**10CFR21 REPORTING OF DEFECTS
AND NON-COMPLIANCE**

COMPONENT: EMD Fuel and Soakback Pumps – Potentially Undertorqued Cover Bolts

Report No. 10CFR21-0123

REV	DATE	PAGE	DESCRIPTION
1	12/21/18	2	In item (iv), added reference to F4B engine application. In item (vii), revised recommended correction action to include a shaft freeness check and provide guidance for reduced bolt torque for previously installed pumps.

Figure 1: Exploded View of Pump P/N 8410219

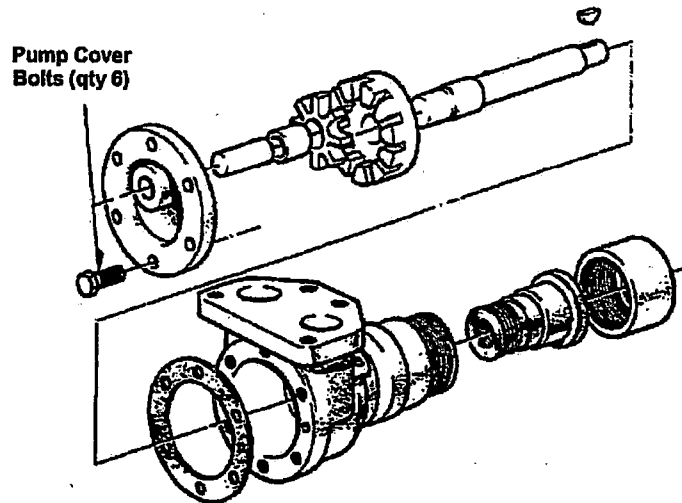
ESI was notified by a nuclear customer of two instances where a bolt was found loose or backed out of the cover of an EMD engine driven fuel pump P/N 8410219. Following notification, ESI inspected remaining pumps in inventory and found instances where one or more the pump cover bolts were loose or lightly torqued. See Figure 1 below for a visual depiction of the pump and bolts.

ESI recommends inspecting the bolt tightness for all pumps. The recommended bolt torque is 108 to 120 in-lbs (12 to 13 Nm). After verifying bolt torque, a shaft freeness check is recommended. The pump shaft should be capable of being rotated by hand in either direction. Due to the small shaft size, this check is commonly performed with a small crescent wrench or with the coupling half installed on the shaft. Inability to rotate by hand indicates loss of end clearance and the pump should be returned to ESI for rework or replacement.

Note: For installed pumps where it is not possible to check shaft freeness, ESI recommends using a reduced bolt torque of 60 to 70 in-lbs (7 to 8 Nm). This is sufficient to ensure the bolts are snug while safeguarding against loss of end clearance that would otherwise go undetected.
